**Re: E&A Team, Inc. Response to the SC Housing Qualifications Package Checklist**

Enclosed please find E&A Team, Inc.'s Qualification Package for South Carolina Housing.

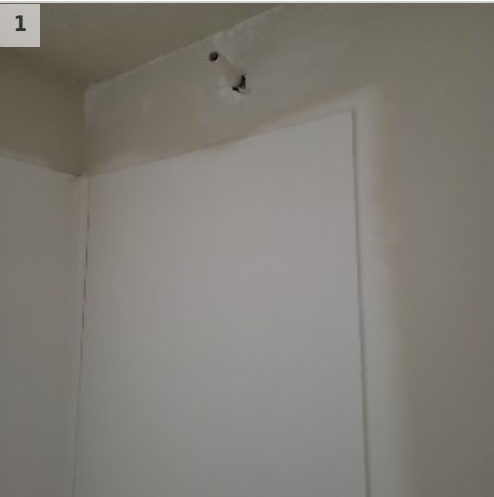
Priority 2 | Scott Reynolds | 2023-12/11 1st Visit  
Plan: A2.1 - FIRST FLOOR BUILDING PLAN | Location: accessible 108  
Created 12-11-2023

Scott Reynolds	Photo 1	11 Dec 07:17 AM
Alva George	UFAS 4.34.5.5 SHOWERS. If a shower is provided, it shall have the following features:(5) Shower unit. A shower spray unit with a hose at least 60 in (1525 mm) long that can be used as a fixed shower head at various heights or as a hand-held shower shall be provided.	13 Dec 07:33 AM

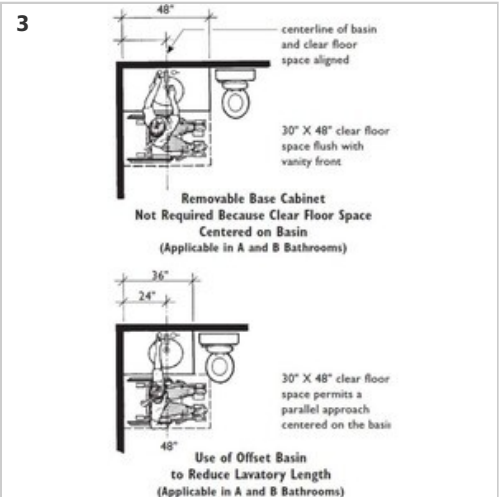
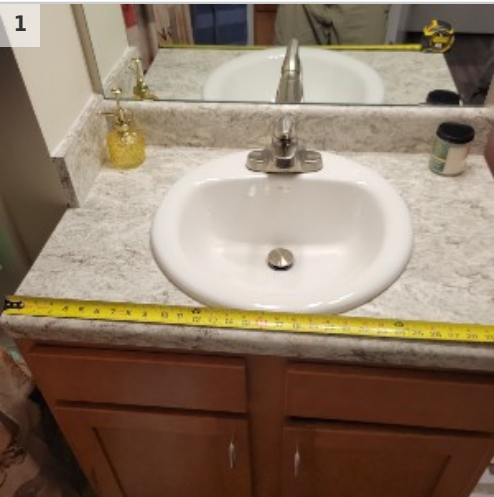
● **#189 - Lavatory center not at 24 inches**  
Priority 2 | Scott Reynolds | 2024-3/13 Site Visit  
Plan: A2.1 - FIRST FLOOR BUILDING PLAN | Location: 101  
Created 03-13-2024

Scott Reynolds	Photo 1	13 Mar 07:02 AM
Scott Reynolds	Photo 2	13 Mar 07:02 AM
Alva George	Photo 3	14 Mar 10:03 AM
Alva George	Fair Housing Act Design Manual-Requirement 7 - Usable Kitchens and Bathrooms	14 Mar 10:49 AM
Alva George	Relocate lavatory	14 Mar 10:50 AM

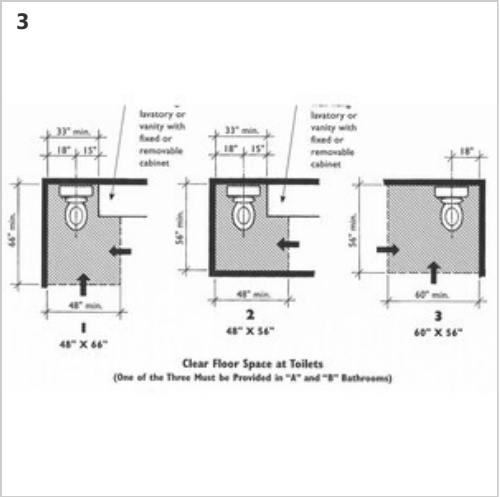
● **#198 - Toilet not 18 inches**  
Priority 2 | Scott Reynolds | 2024-3/13 Site Visit  
Plan: A2.1 - FIRST FLOOR BUILDING PLAN | Location: 110  
Created 03-13-2024

Scott Reynolds	Photo 1	13 Mar 07:53 AM
Scott Reynolds	Photo 2	13 Mar 07:54 AM
Alva George	Fair Housing Act Design Manual - Requirement 7 Usable Kitchens and Bathrooms Part A:Usable Kitchens Part B: Usable Bathrooms	14 Mar 12:41 PM
Alva George	Photo 3	14 Mar 12:41 PM

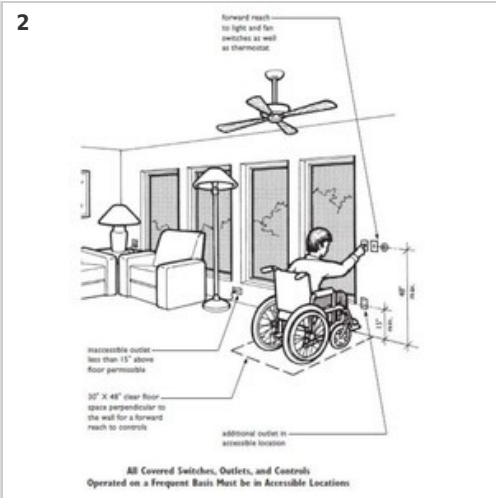
● **#201 - Thermostat above 48**  
Priority 2 | Scott Reynolds | 2024-3/13 Site Visit  
Plan: A2.2 - SECOND FLOOR BUILDING PLAN | Location: 206  
Created 03-13-2024

Scott Reynolds	Photo 1	13 Mar 08:31 AM
Alva George	Fair Housing Act Design Manual - Requirement 5 -Light Switches, Electrical Outlets, Thermostats, and Other Environmental Controls in Accessible Locations ANSI A117.1[2003]1004.9 Operable Parts. Lighting controls electrical switches and receptacle outlets, environmental controls, and user controls for security or intercom systems shall comply with Sections 309.2 and 309.3.	14 Mar 12:53 PM
Alva George	Photo 2	14 Mar 12:54 PM

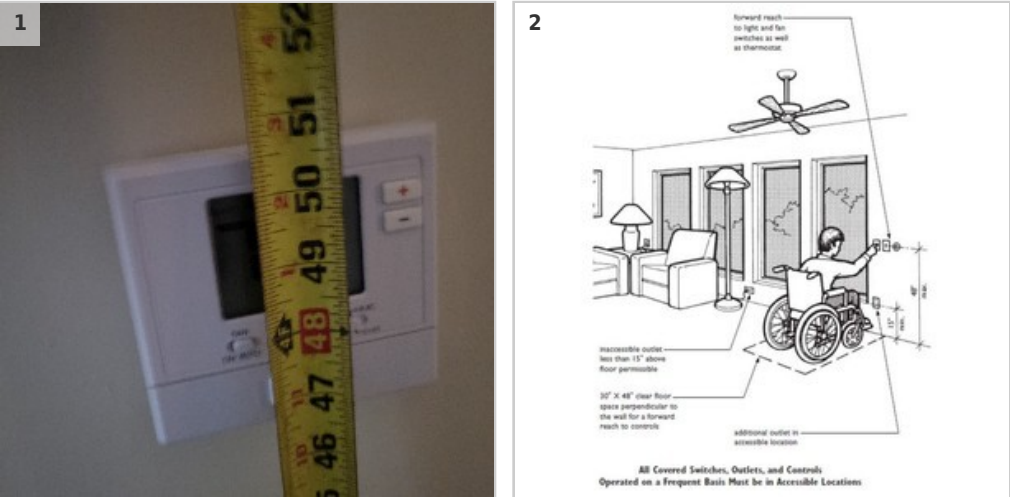
● **#202 - Thermostat above 48 inches**  
Priority 2 | Scott Reynolds | 2024-3/13 Site Visit  
Plan: A2.2 - SECOND FLOOR BUILDING PLAN | Location: 212  
Created 03-13-2024

Task messages (time in PDT)		
Scott Reynolds	Photo 1	13 Mar 08:43 AM
Alva George	Fair Housing Act Design Manual - Requirement 5 -Light Switches, Electrical Outlets, Thermostats, and Other Environmental Controls in Accessible Locations ANSI A117.1[2003]1004.9 Operable Parts. Lighting controls electrical switches and receptacle outlets, environmental controls, and user controls for security or intercom systems shall comply with Sections 309.2 and 309.3.	14 Mar 12:54 PM
Alva George	Photo 2	14 Mar 12:55 PM

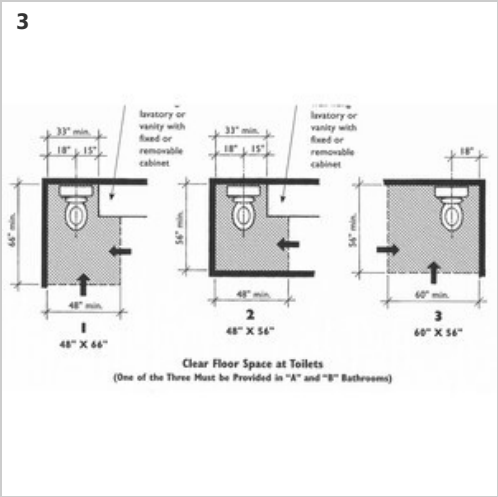
● **#203 - Toilet not at 18 inches**  
Priority 2 | Scott Reynolds | 2024-3/13 Site Visit  
Plan: A2.3 - THIRD FLOOR BUILDING PLAN | Location: 306  
Created 03-13-2024

Task messages (time in PDT)		
Scott Reynolds	Photo 1	13 Mar 09:03 AM
Scott Reynolds	Photo 2	13 Mar 09:03 AM
Alva George	Photo 3	14 Mar 12:58 PM
Alva George	Fair Housing Act Design Manual - Requirement 7 Usable Kitchens and Bathrooms Part A:Usable Kitchens Part B: Usable Bathrooms	14 Mar 12:58 PM

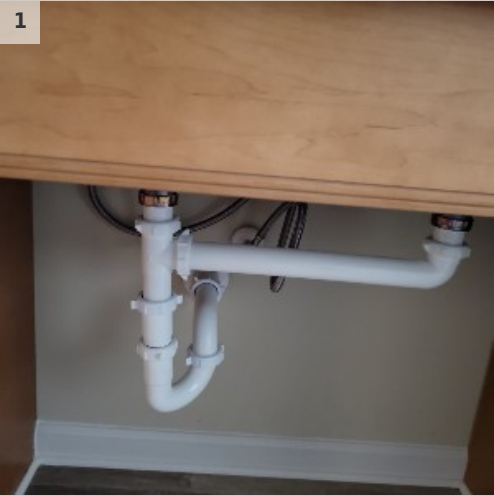
Priority 2 | Scott Reynolds | 2024-3/13 Site Visit  
Plan: A2.1 - FIRST FLOOR BUILDING PLAN | Location: accessible 106  
Created 03-13-2024

Scott Reynolds	Photo 1	13 Mar 07:41 AM
Alva George	UFAS 4.34.6.5* SINK. The sink and surrounding counter shall comply with the following requirements (see Fig. 51):(8) There shall be no sharp or abrasive surfaces under sinks. Hot water and drain pipes under sinks shall be insulated or otherwise covered.	14 Mar 12:36 PM

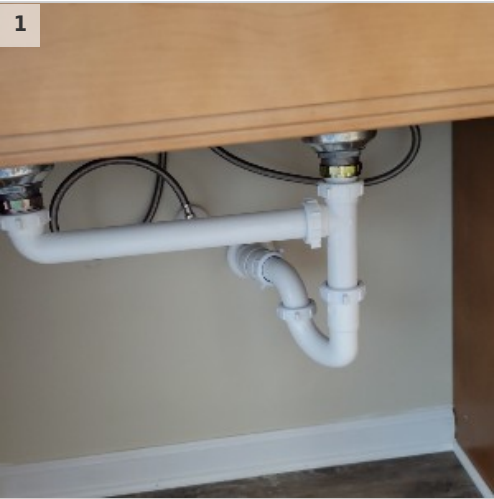
Priority 2 | Scott Reynolds | 2024-3/13 Site Visit  
Plan: A2.1 - FIRST FLOOR BUILDING PLAN | Location: accessible 107  
Created 03-13-2024

Scott Reynolds	Photo 1	13 Mar 07:40 AM
Alva George	UFAS 4.34.6.5* SINK. The sink and surrounding counter shall comply with the following requirements (see Fig. 51):(8) There shall be no sharp or abrasive surfaces under sinks. Hot water and drain pipes under sinks shall be insulated or otherwise covered.	14 Mar 12:30 PM

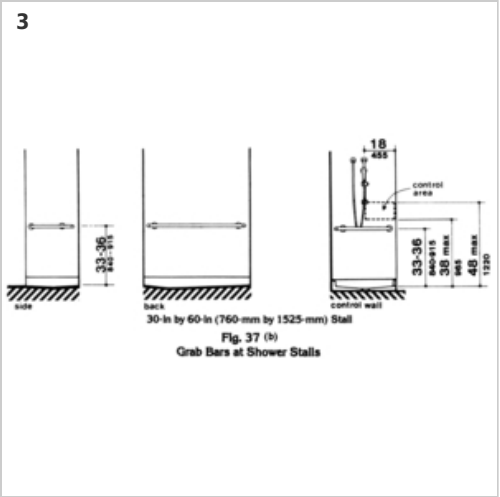
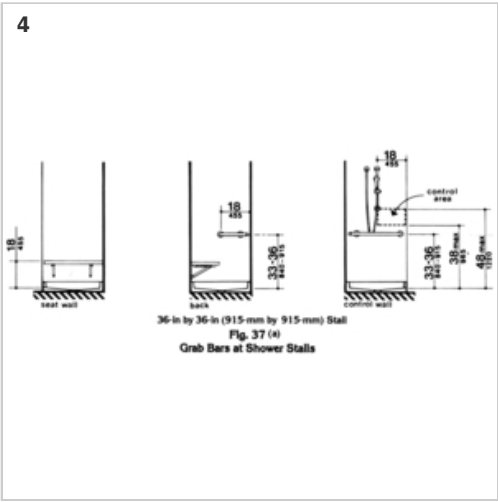
**#200 - Shower control not off set.**  
Priority 2 | Scott Reynolds | 2024-3/13 Site Visit  
Plan: A2.1 - FIRST FLOOR BUILDING PLAN | Location: accessible 111  
Created 03-13-2024

Scott Reynolds	Photo 1	13 Mar 07:58 AM
Scott Reynolds	Photo 2	13 Mar 07:59 AM
Alva George	UFAS 4.34.5.5 SHOWERS. If a shower is provided, it shall have the following features:(4) Controls. Faucets and other controls shall be located as shown in Fig. 37 and shall comply with 4.27.4. In the shower stall in Fig. 35(a), all controls, faucets, and the shower unit shall be mounted on the side wall opposite the seat.	14 Mar 12:49 PM
Alva George	Photo 3	14 Mar 12:50 PM
Alva George	Photo 4	14 Mar 12:51 PM

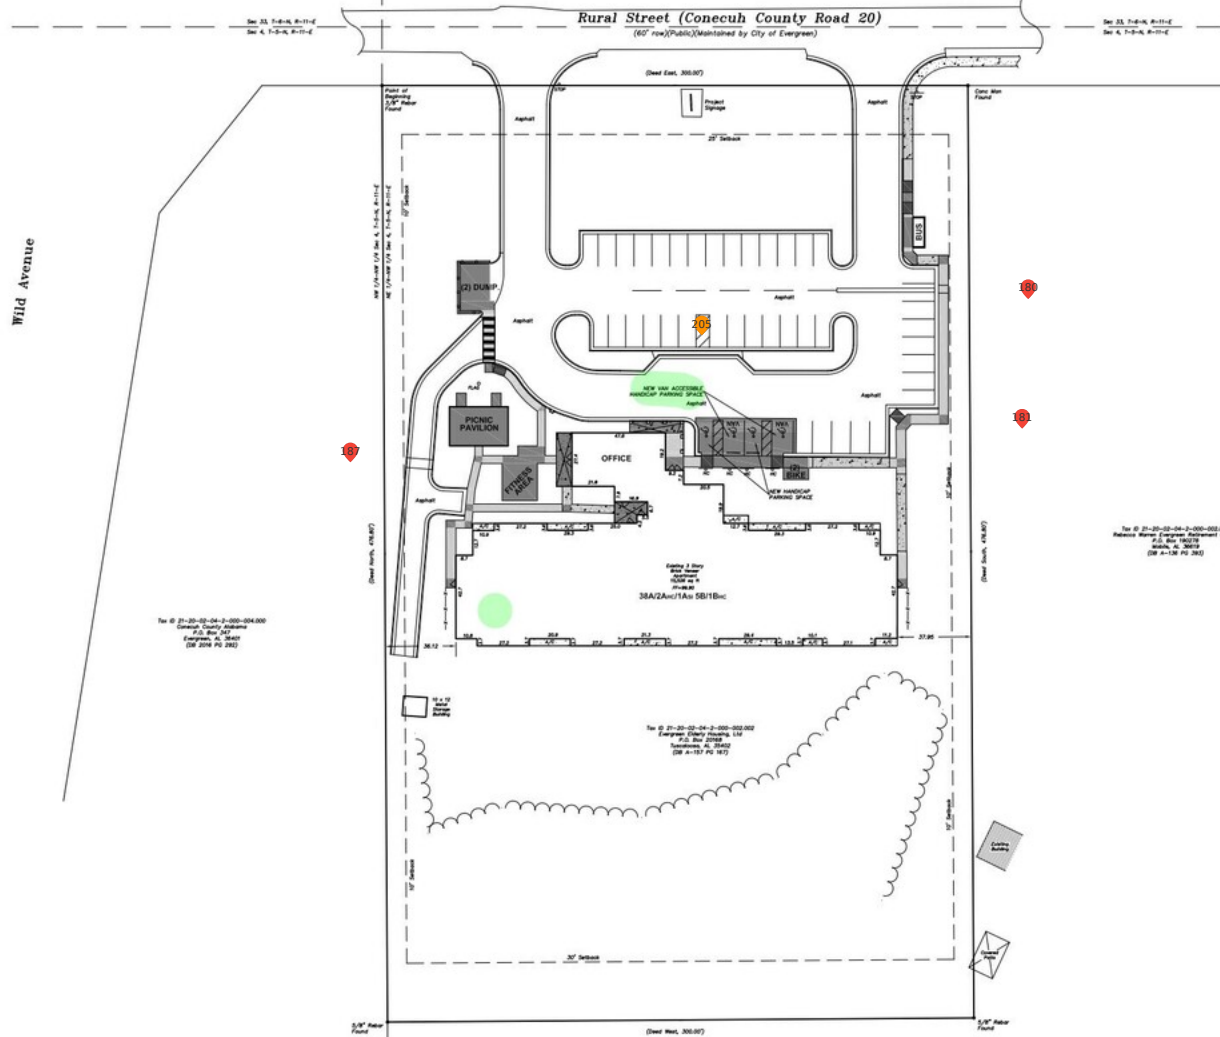
**#205 - Needs 5th accessible parking space**  
Priority 2 | Scott Reynolds | 2024-3/13 Site Visit  
Plan: 01. - Accessibility Plan | Location: second row parking lot  
Created 03-13-2024

Scott Reynolds	Photo 1	13 Mar 09:28 AM
Alva George	Note the accessible route will take a parking space and the access aisle. Plans show [2] Van Accessible Parking Spaces and two Standard Accessible Parking Spaces.	14 Mar 01:13 PM
